RE: Transport Airplane Metallic and Composite Structures Working Group – Final Recommendation Report on Single Load-Path Structures

# **Transport Airplane Metallic and Composite Structures Working Group – Recommendation Report to FAA Single Load-Path Structures**

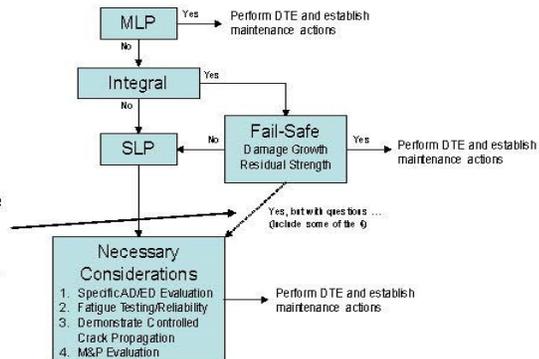
**Airbus Comment:** Airbus would not like to create such an intermediate solution for Integral structures: *If there are questions about the confidence in the fail-safe evaluation, some aspects of the specific considerations for SLP could be necessary.* The fail safe assessment will have a binary conclusion: either to be considered as SLP or not. If we allow this type of intermediate solution, the OEMs will end up in questioning and discussing halfway solutions with the authorities case by case. Also please delete the dotted arrow in the figure above

**Response:** The figure is included as reference only as a guide to the rest of the report, and not intended for the guidance. The dotted line ‘with questions’ was suggested by the FAA. These ‘questions’ are elements of the key considerations for the fail-safe evaluation (see next slide).

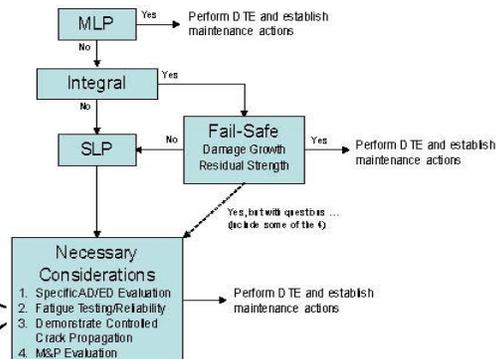
Page 12 (Introduction):

### Response: Section 4.2.6.2 Eval. Criteria

The key considerations that were proposed for the evaluation of **residual strength** capability are:

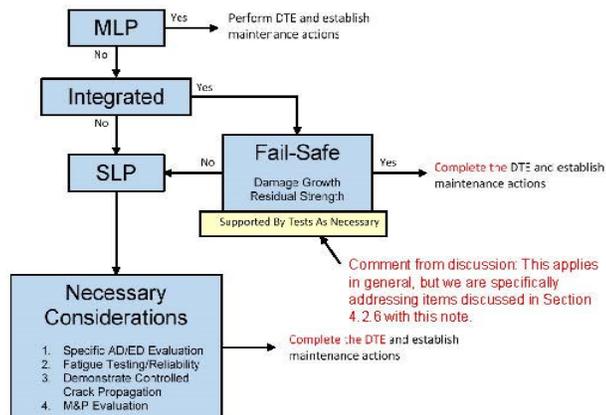
Page 12 (Introduction):

**Response:** Integrally Stiffened Panels and Monolithic Structure: The applicant should perform an evaluation of these structures using the definition of fail-safe given in AC 25.571-1D. Those structures that do not have fail-safe capability should be treated as SLP. **Key elements of the evaluation should be supported by tests and processing controls as necessary. For example, an integrally stiffened wing lower cover using a completely new material or processing method may need fracture/crack growth rate testing, fatigue testing, and/or special M&P evaluations to support the fail-safe evaluation.** This topic is discussed in detail in Section 4.2.6.
